SUBJECT: FCC Application for (FCC ID : **2AFWN-WA23FO012W0**)

We, SOLUM CO., LTD. request to change for authorized product (FCC ID : 2AFWN-WA23FO012W0) for the following reason

Antenna photo	Antenna location photo

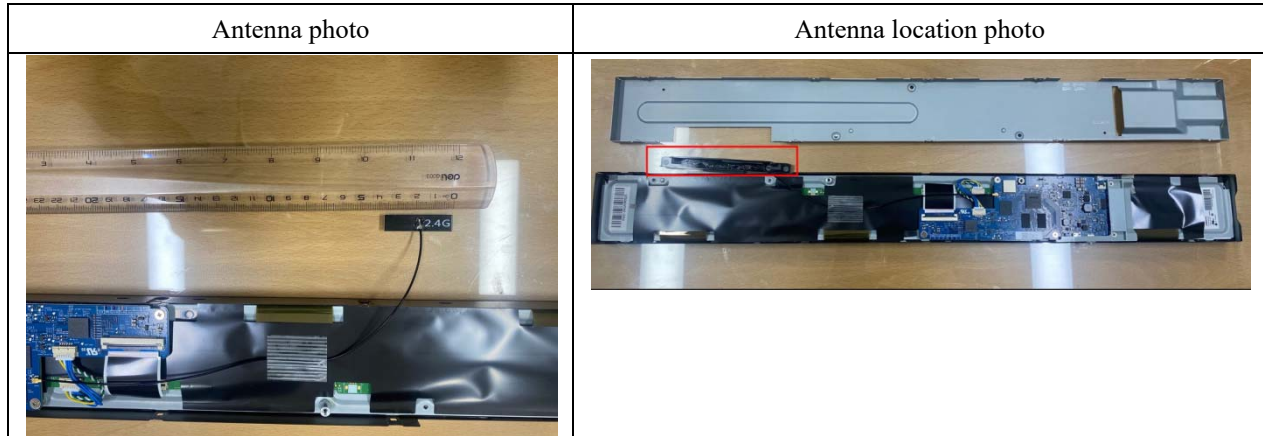
- Operational description Antenna specification add
- The absolute gain (2.50 dBi) of the antenna being changed does not exceed the absolute gain (3.62 dBi) of the antenna before the change.
